Hope Creek Generating Station
Facility Operating License No. NPF-57
NRC Docket No. 50-354

Subject: Response to Request for Additional Information Regarding Relief Request
Associated with the Second Inservice Inspection (ISI) Interval

DRAFT REQUEST FOR ADDITIONAL INFORMATION
RELATED TO RELIEF REQUEST HC-I2-RR-A25
FOR SECOND TEN-YEAR INSERVICE INSPECTION INTERVAL
HOPE CREEK GENERATING STATION
DOCKET NO. 50-354

Figure 2.1.3-1
Limitation Due to Reactor Vessel Closure Head to Flange Configuration

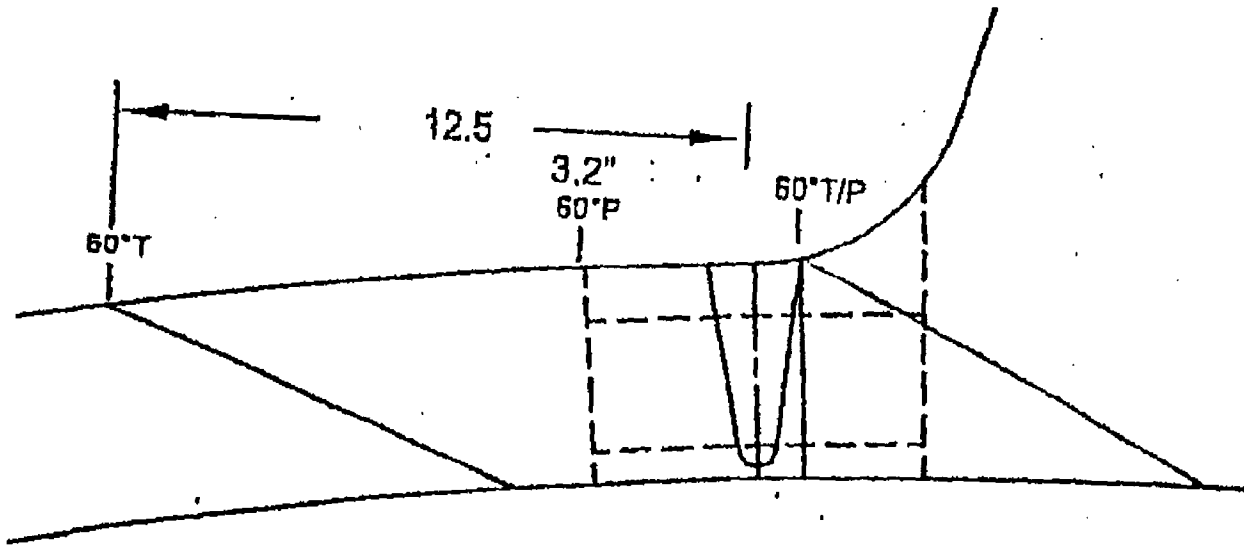
- 2.1.3 Relief request HC-I2-RR-25 provided Figure 4 as a supporting sketch to demonstrate that the RPV closure head Weld RPV1-W20 cannot be examined to the full extent required by the ASME Code. However, the dimensions on this figure are not legible. Please re-submit the drawing with legible dimensions.

An updated sketch for RPV closure head weld RPV1-W20 is provided in Figure 2.1.3-1.

Figure 2.2-1

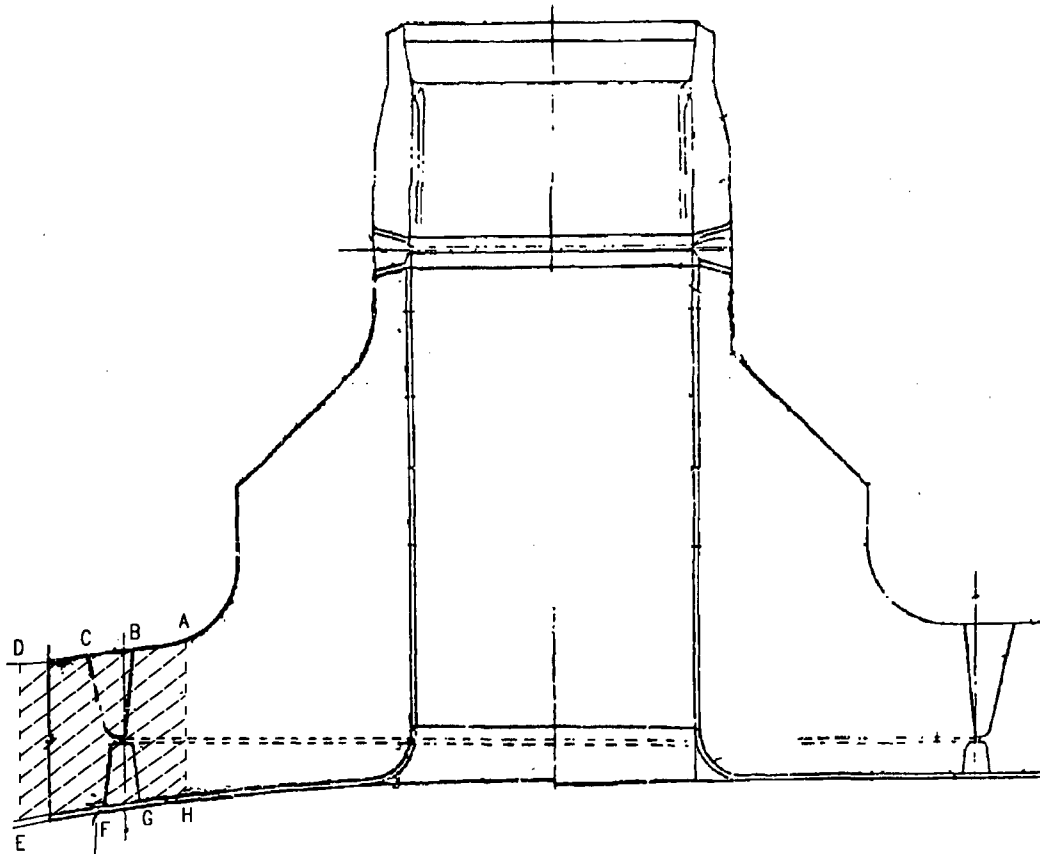
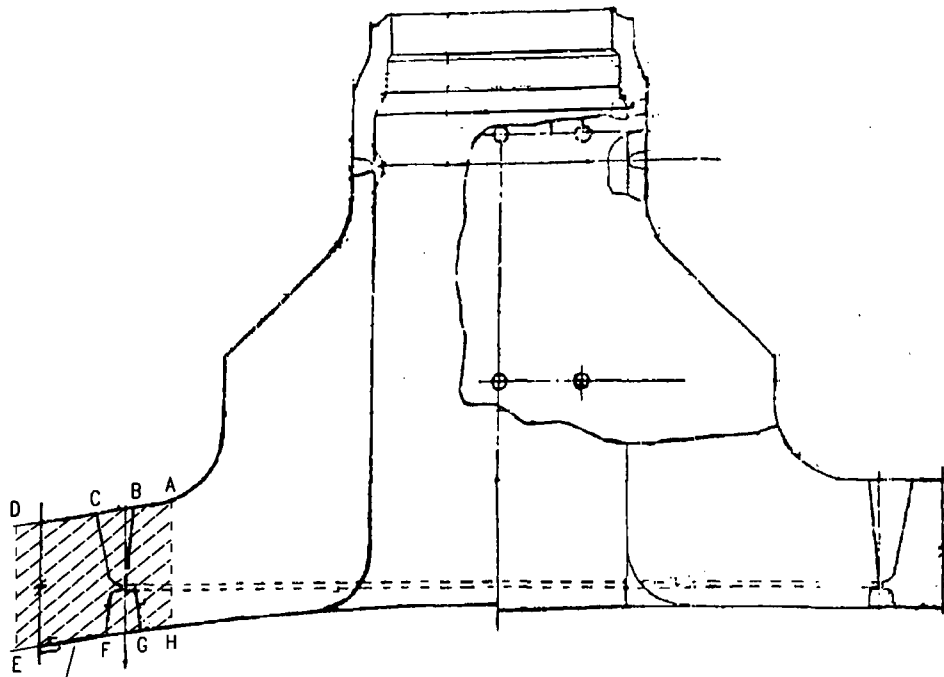
The coverage sketch included in the licensee's submittal for all Examination Category B-D nozzle-to-vessel welds is labeled as "typical". Please re-submit cross-sectional sketches for each type of nozzle-to-vessel weld listed in Table 1, and/or provide full written descriptions, describing the nozzle geometries, the ASME Code-required volumes, and areas of completed coverage (near surface, inner 15 percent, and full volume) for each of the techniques used on these welds. Summarize the scanning directions and techniques, list the materials for the base metal and weld, and clarify whether the methods used have been qualified in accordance with performance demonstration requirements per ASME Code, Section XI, Appendix VIII.

Cross-sectional sketches for each type of nozzle-to-vessel weld listed in Reference 1 Table 1 are provided in Figures 2.2-1 through 2.2-7. The scanning directions and techniques are listed in Table 2.2-1 below. The base metal for the reactor vessel shell and head is SA-533 Grade B Class 1. Base metal for the nozzles is SA-508 Class 2. Specified weld materials for carbon steel are SA-558, SA-559, or SA-233.

RECIRCULATION INLET NOZZLE N2

LIMITED TO ONE DIRECTION
BELOW DUE TO GEOMETRY

SCAN TRANSVERSE IN
ONE DIRECTION ONLY

Figure 2.5.2-1
CP206

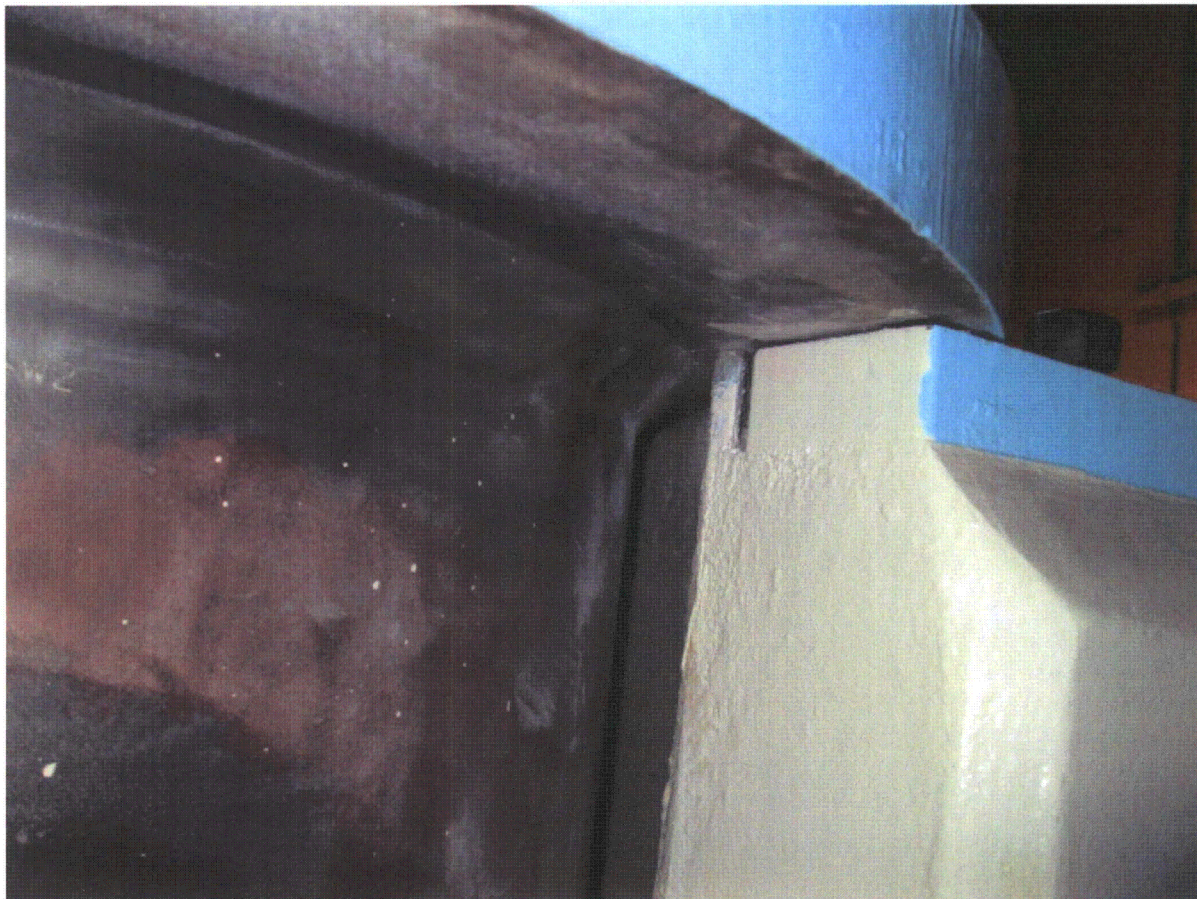
- 2.5.2 The drawing of the Core Spray Pump included as Figure 19 in the licensee's submittal, does not adequately demonstrate limited accessibility for surface examination of Weld CP-206-CSP-W2. In this drawing, it appears that access to the weld may be sufficient for performing outside surface examination. Please submit further information to demonstrate the inaccessibility, and show the areas where limited coverage has been obtained.

Photographs showing the limited accessibility between the concrete pedestal and core spray pump CP-206 casing are provided in Figures 2.5.2-1 and 2.5.2-2.
